DESIGN/DEVELOPMENT REVIEW COMMISSION
URBAN DESIGN REVIEW DISTRICT
EVALUATION SHEET
Case #2

ADDRESS: 911 Washington Street

NATURE OF REQUEST: Request for Certificate of Design Approval for new construction of a hotel.

Sheet Title:
SITE PLAN

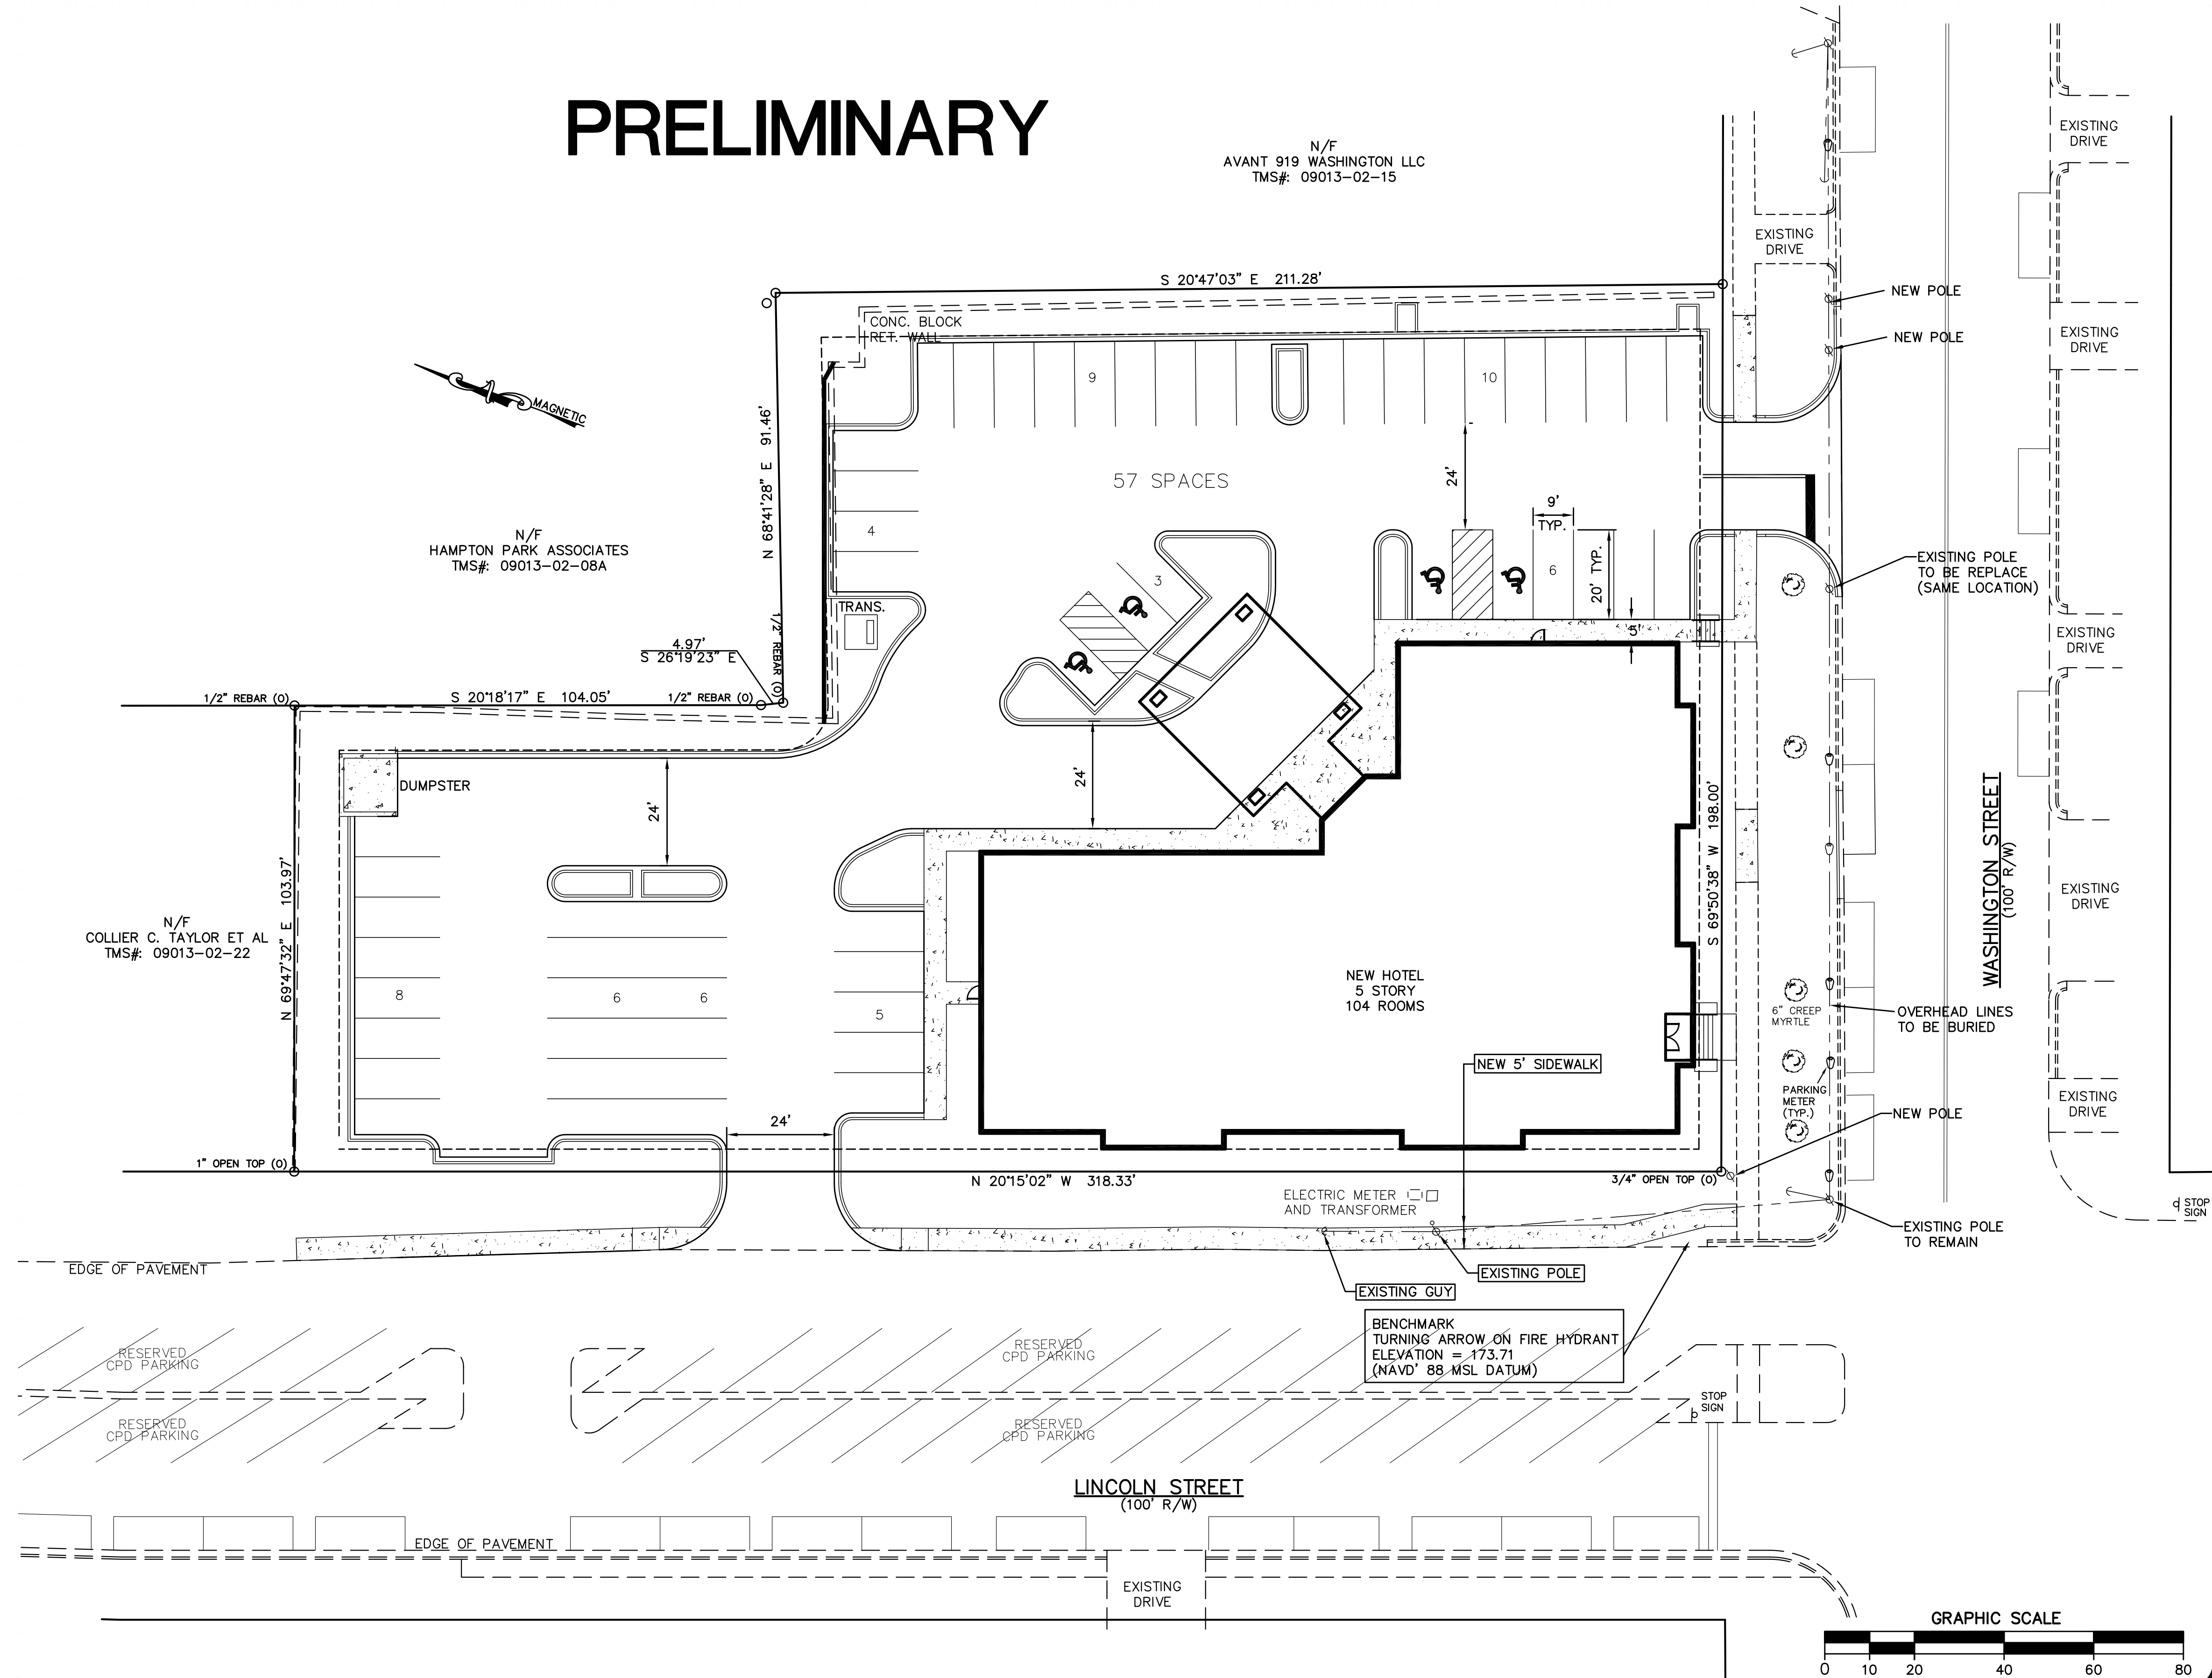
The setback is five feet on both street frontages, which is consistent with the guidelines and with adjacent development. The challenge with this property is the grade change on Lincoln Street, which may require an additional few feet to accommodate the required sidewalk, buffer, and change in grade between the curb and the finished floor elevation.

While a building entrance is provided on Washington Street, which is the primary façade, there is a back entrance adjacent to the parking lot, which will clearly be the primary entrance for people arriving by car, and the only entrance accessible by ADA standards, since the entrance on Washington Street requires steps to navigate the grade change. A pedestrian coming from the sidewalk- or a patron who wishes to navigate around the Vista without a car- must also navigate stairs to get from the public sidewalk to the rear entrance off of the parking lot. One of the two entrances to the building needs to be accessible for all pedestrians, including those with disabilities.

The parking is located properly to the rear of the building. The project will be required to fully comply with the City's landscape ordinance, which will include evergreen screening along the perimeter as well as tree islands within the lot.

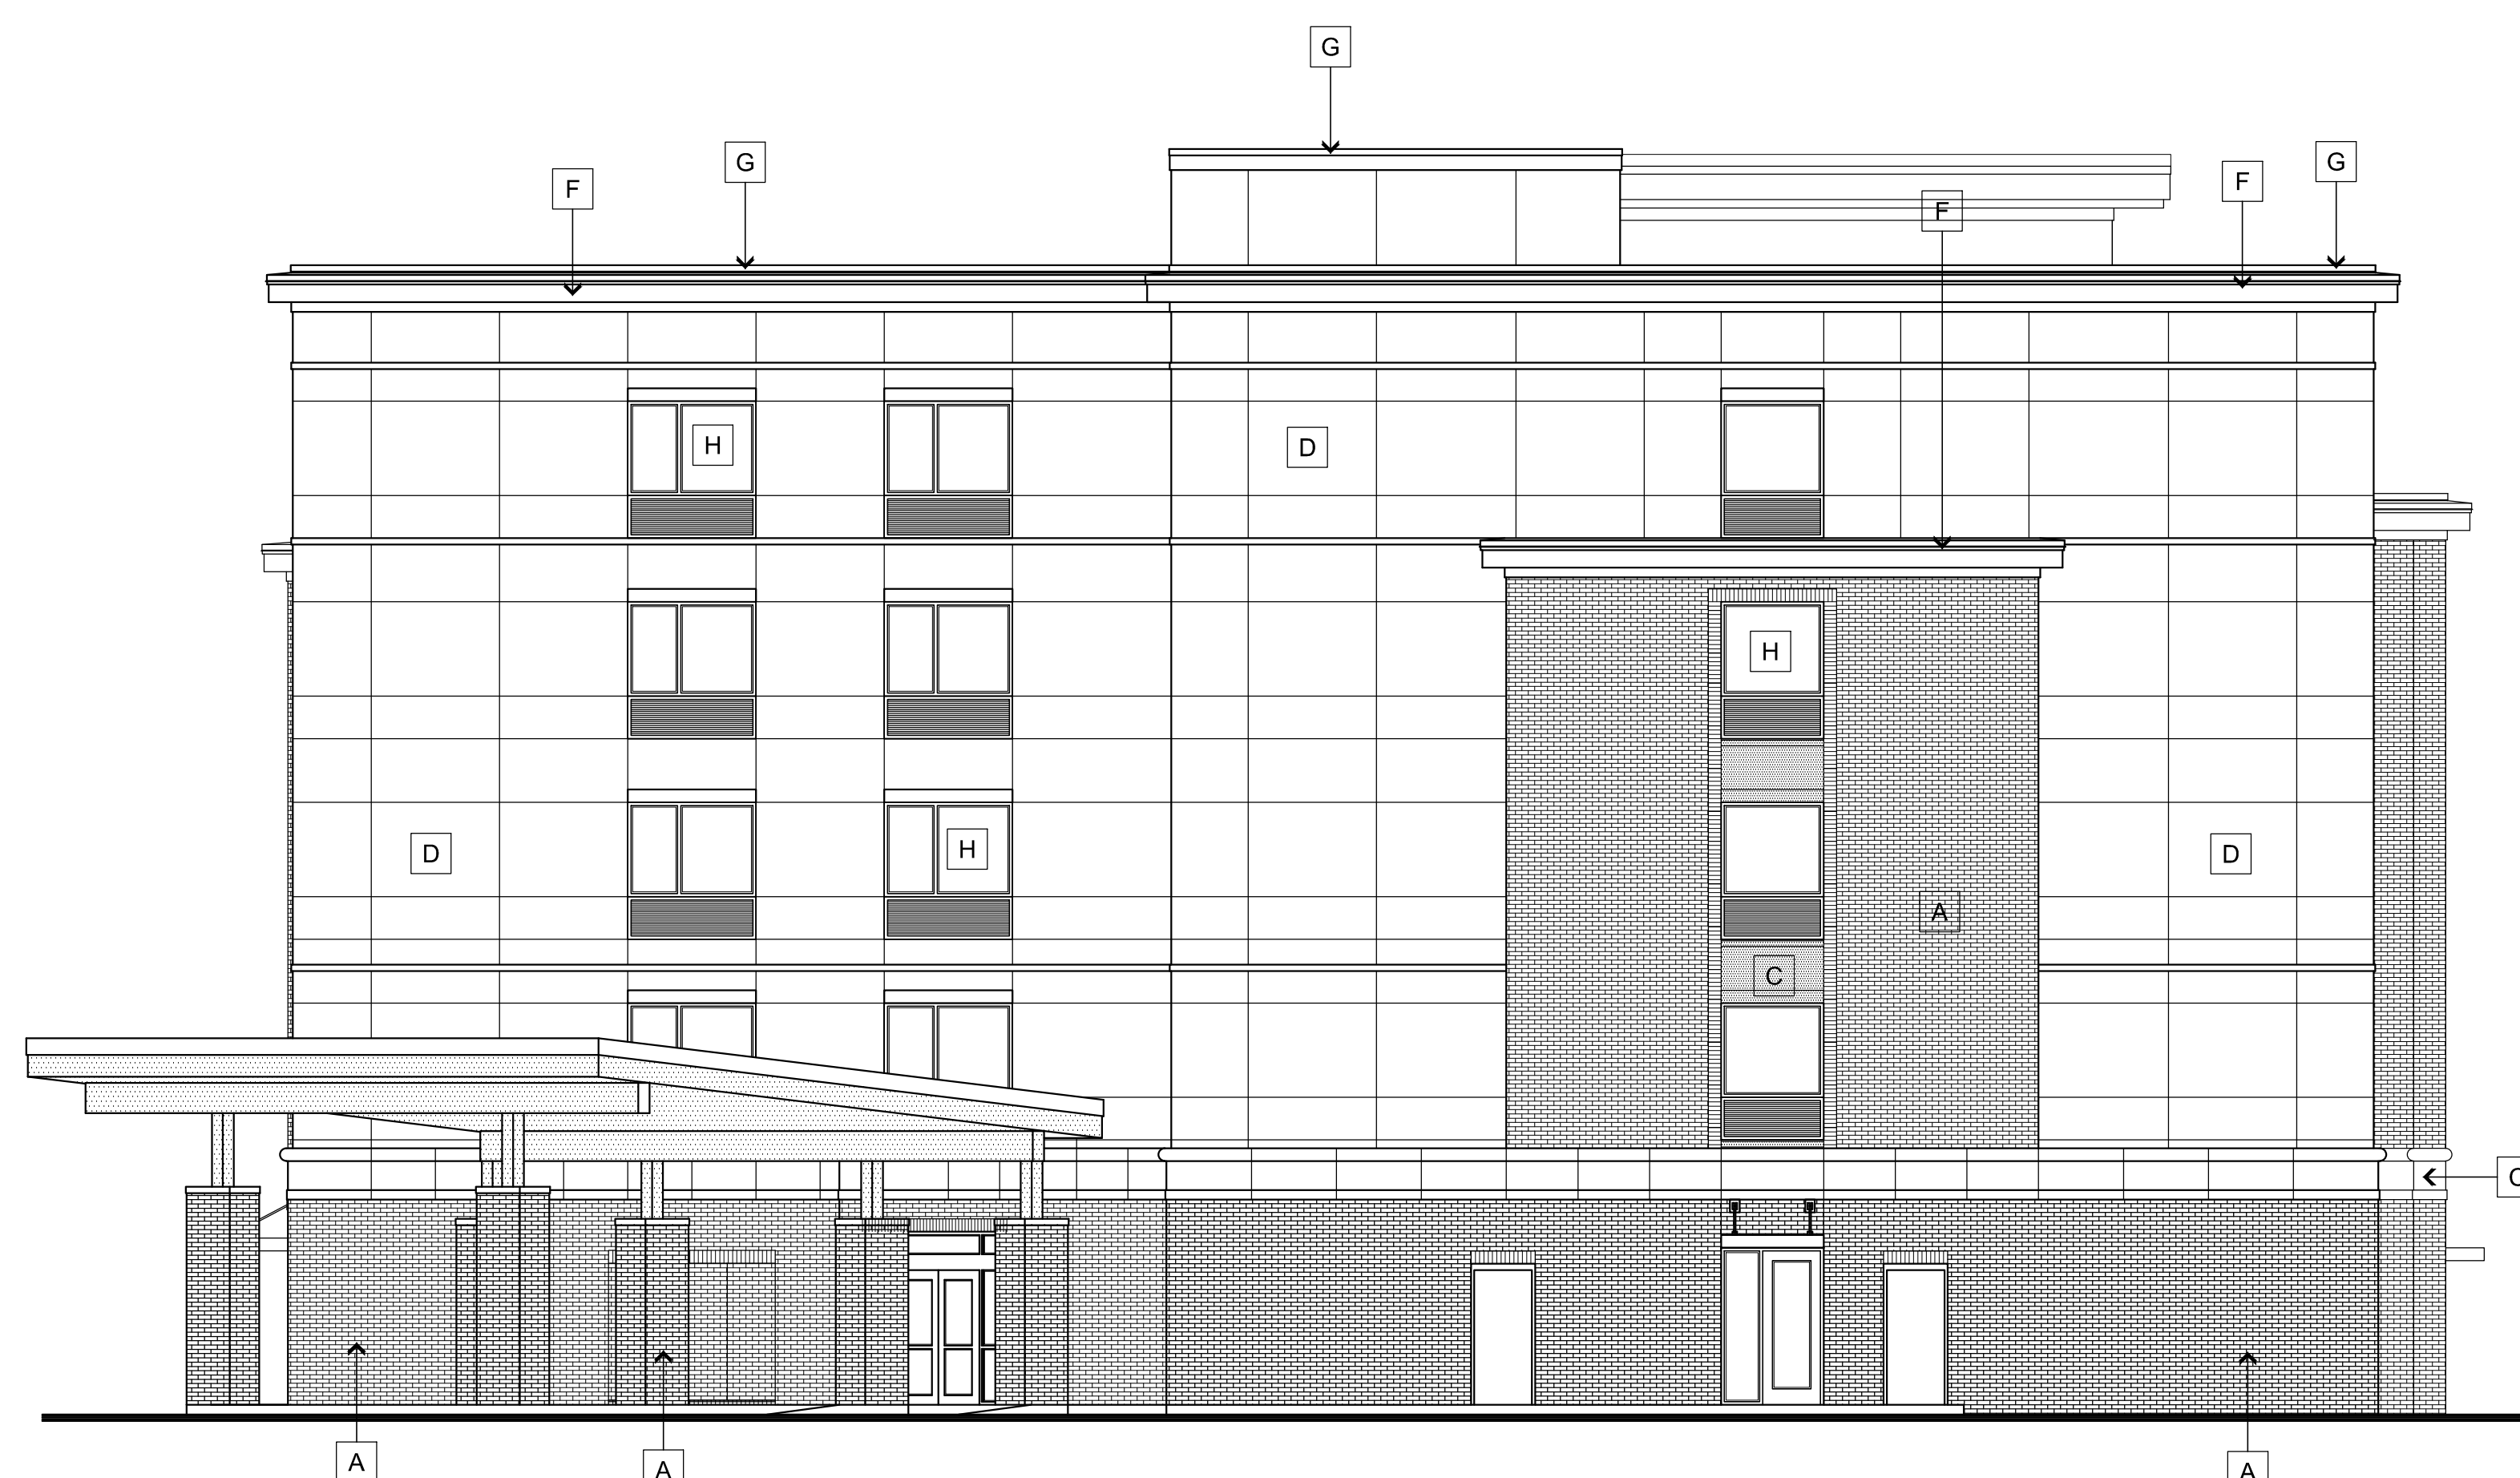
While the building has a defined base, middle, and top, the upper floors are relatively flat with only a change in color and materials. There is not a strong relationship between the upper floors and the base of the building with continuous piers or pilasters.

The proportion of openings on the lower and upper floors of the Washington Street façade appears to be close to the recommended 70/40%, respectively.

The Lincoln Street façade has some sections of blank wall along the first level, with what appears to be recessed brick panels. Depending on the programming inside (pantry and breakfast) spandrel glass might be a better solution to continue the pattern of openings.

The corner of the Lincoln Street façade is blank on the upper floors. This is a highly visible corner and needs more fenestration on the upper floors.

Given the mass of the building, there is a relative lack of architectural detailing to add richness to the flatness of the building.

The first level of the building is a long flat wall with little articulation in the way of piers or other details. There are a couple of projecting bays but as noted previously, little relationship between the upper floors and the first level. As well, the first floor along Lincoln Street has some long stretches of blank brick wall. More thought should be given to how to better address this façade with the interior program of the building.

The building sits on a corner, but there is nothing about the architecture that emphasizes the corner.

More articulation and fenestration should be added to the first floor along Lincoln Street.

The entrance is near the corner but the building does not have corner features that emphasize its placement on the corner or the entrance. The building design should reflect this location and take advantage of the visibility and accessibility of the corner.

The building is very monolithic in its design; having EFIS (or stucco) as the primary material will not add texture or detail to the building.

The primary building materials are EFIS and brick; brick is an appropriate material for City Center, but EFIS is not. With two colors of brick and three colors of EFIS, color is being used to define the building, rather than articulation of architectural elements and details that provide definition through relief, depth and shadow. Staff would recommend simplifying the materials palette; brick would be a better choice and would provide more opportunities for architectural detailing to add interest and character to the design.

The wall materials on the upper façade do not relate to the first floors storefront design and materials.

More information is needed about the windows sections; upper floor windows should be punched with enough depth to create shadow lines, typically a minimum of 4-5 inches on a building of this scale.

The piers are not articulated on the upper floors. As noted previously, there is no continuity between the building's upper floors and the first floor, in massing or materiality.

The staff recommendation is to defer any approval of the request until the outstanding items are addressed.
